DECISION OF THE PLANNING ADMINISTRATOR

SUBDIVISION CASE NO. SUB17-02

REQUEST: Application Summary: An 11-lot subdivision ("9th Court Addition") on the east side of Sunnyside Road SE, just north of Baxter Road SE. The two existing residences along Sunnyside Road SE would remain.

9TH COURT ADDITION - TENTATIVE SUBDIVISION PLAN

MRB ENTERPRISES, INC.
9TH COURT ADDITION SUBDIVISION
5320 & 5390 SUNNYSIDE ROAD SE
SALEM, OREGON
TENTATIVE SUBDIVISION PLAN

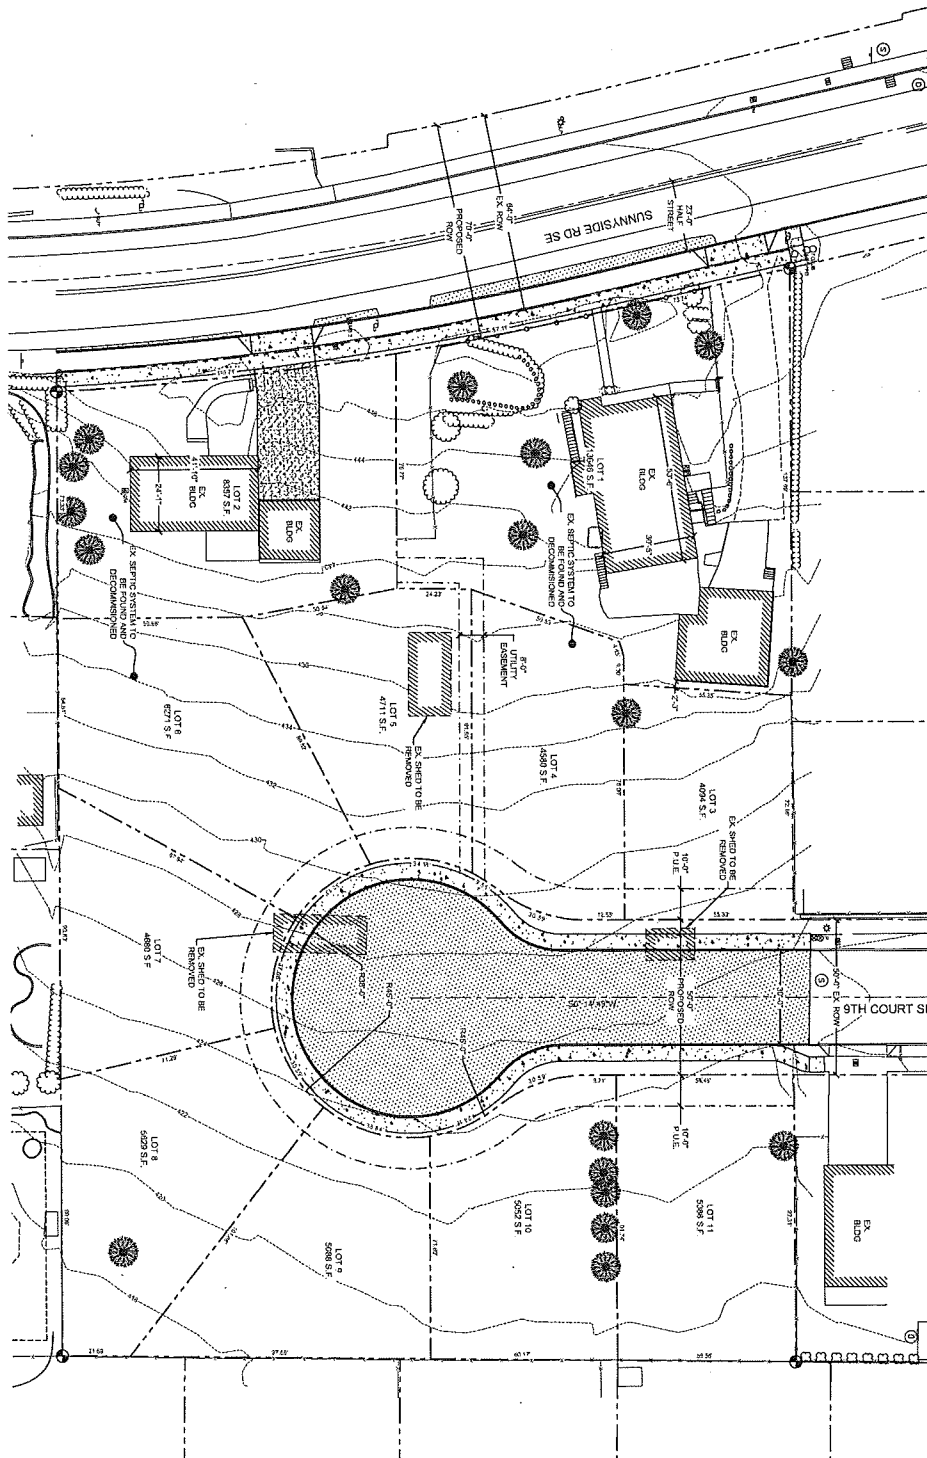
The existing single family dwellings will remain on the subject property, on Lots 1 and 2. A detached garage will also remain on Lot 1. The applicant's site plan shows the footprint of the existing residences and garage demonstrates that their location will continue to meet all applicable setback standards once the boundaries of Lots 1 and 2 are recorded.² In addition, SRC Chapter 511, Table 511-4 sets forth a maximum rear

² The existing detached garage is approximately 11 feet in height, requiring a 2 foot setback from the rear property line pursuant to SRC Chapter 511, Table 511-3. The tentative subdivision plan shows the garage setback from the rear property line by 2 feet, 3 inches.

yard coverage of 25 percent for all structures accessory to a Single Family or Two Family use. The existing detached garage on Lot 1 is approximately 846 square feet in size, requiring a rear yard of at least 3,384 square feet in order to meet the maximum lot coverage requirement. The tentative subdivision plan shows Lot 1 with a rear yard of approximately 2,900 square feet. In order to ensure that the existing detached garage does not exceed the maximum lot coverage allowed on Lot 1, the following condition shall apply:

The eastern portion of the subject property is primarily undeveloped, except for several outbuildings. The tentative subdivision plan indicates that the applicant plans to remove these buildings prior to development. Relative to the tentative subdivision plan, two of the accessory structures on the eastern portion of the property would cross proposed lot lines, building envelopes, and the proposed right-of-way for the extension of 9th Court SE. The third accessory structure, an existing shed, would occupy Lot 5. As noted in findings above, all lots within the subdivision, including Lot 5, will be rezoned to RS upon recording of the plat. Structures such as the outbuildings are only allowed in the RS zone as accessory to a permitted use. In order to ensure that the subject property complies with the setback and use requirements of the RS zone upon recording of the plat, the following condition shall apply:

Relative to the tentative subdivision plan, two of the accessory structures located outside the proposed boundaries of Lots 1 and 2 would cross proposed lot lines, building envelopes, and the proposed right-of-way for the extension of 9th Court SE. Condition 1 requires the applicant to obtain demolition permits and remove these structures prior to final plat, thereby ensuring compliance with SRC 800.015(a).

The applicant's preliminary utility plan does not demonstrate specific drainage facilities to be constructed in conjunction with Sunnyside street improvements. The applicant's engineer shall design stormwater facilities for Sunnyside pursuant to PWDS and SRC 71.

Condition 1: Rear lot lines of Lot 1 shall be configured so as to provide a minimum rear yard area of 3,384 square feet on Lot 1.

Condition 2: Obtain demolition permits and remove all accessory structures located outside the boundaries of Lots 1 and 2.
